# STAFF REPORT

Case File: #CU-2016-02

City of Garibaldi  
Conditional Use Permit Request  
(Planning Commission Public Hearing Item)

**REQUEST:** The applicant is requesting conditional use approval to authorize the development of a 24 unit multi-family dwelling in the Commercial Zone, including a parking area, open space, landscaping, and a playground.

Figure 1.

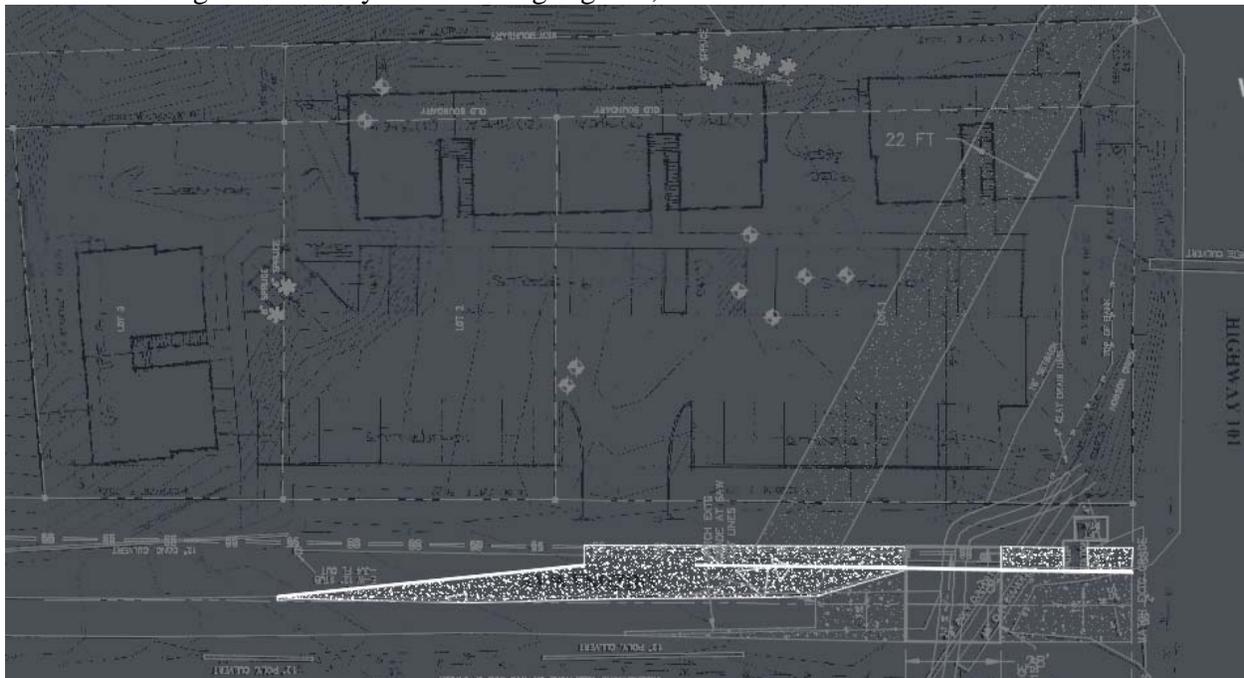
- a. Saw-cutting 1 foot in to the existing pavement edge to provide a clean and sealed pavement joint
- b. Providing paved roadway lane from the saw cut to 11 feet east of the centerline of right-of-way and an additional 6 feet of paved pedestrian shoulder consisting of 3-inch compacted thickness of Class C asphalt over 9 inches compacted thickness of  $\frac{3}{4}$ "-0" crushed rock over compacted subgrade

- e. Providing a 4-inch wide painted white fog line 11 feet east of centerline south of the south access to the Hwy 101 N right-of-way and a 4-inch wide painted white fog line from the north end of the access along the edge of pavement to the end of the taper to the north

8. Site pedestrian sidewalks shall connect to sidewalk area shown on Figure 1.
9. The applicant shall provide 39 parking stalls and parking area layout in accordance with the provisions of GMC Chapter 18.125. Parking shall include appropriate provisions for ADA accessibility.
10. All parking spaces and parking area layout shall be clearly identified and marked.

## Exhibit “B”

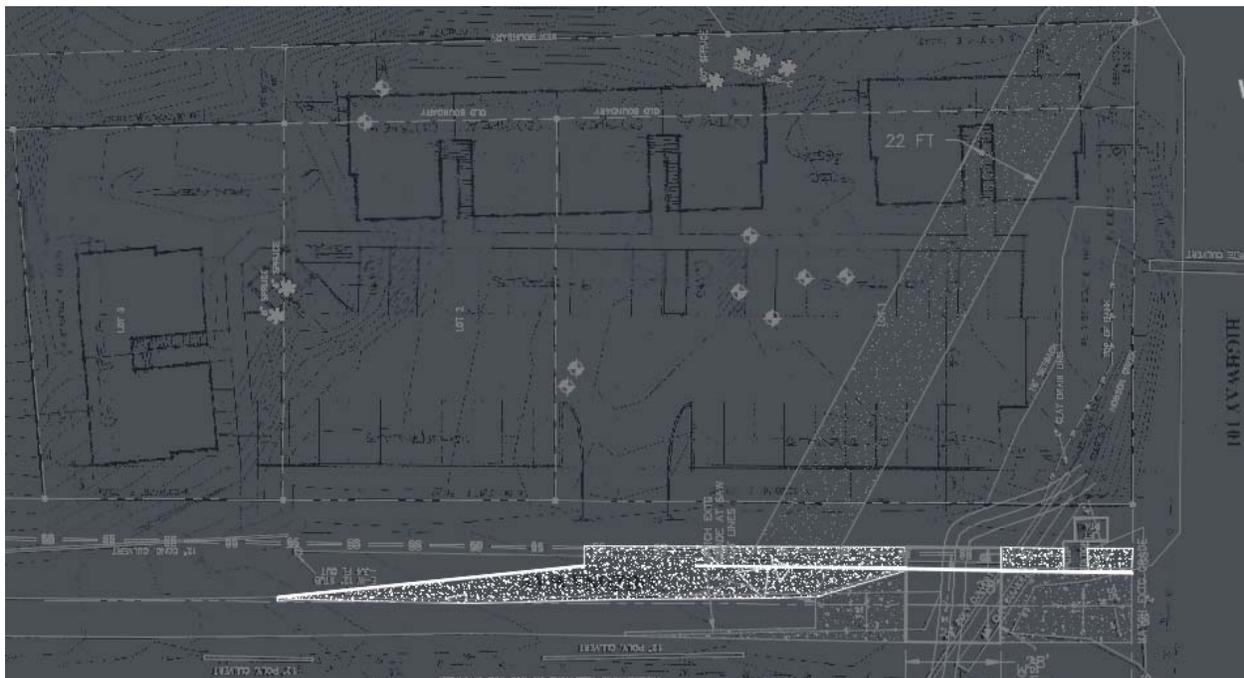
I have reviewed the proposed project and recommend the following street improvements.

1. Half-street improvements on the east side of Arizona Way from the north end of the access to the Hwy 101 N right-of-way consisting of:
  - a. Saw-cutting 1 foot in to the existing pavement edge to provide a clean and sealed pavement joint
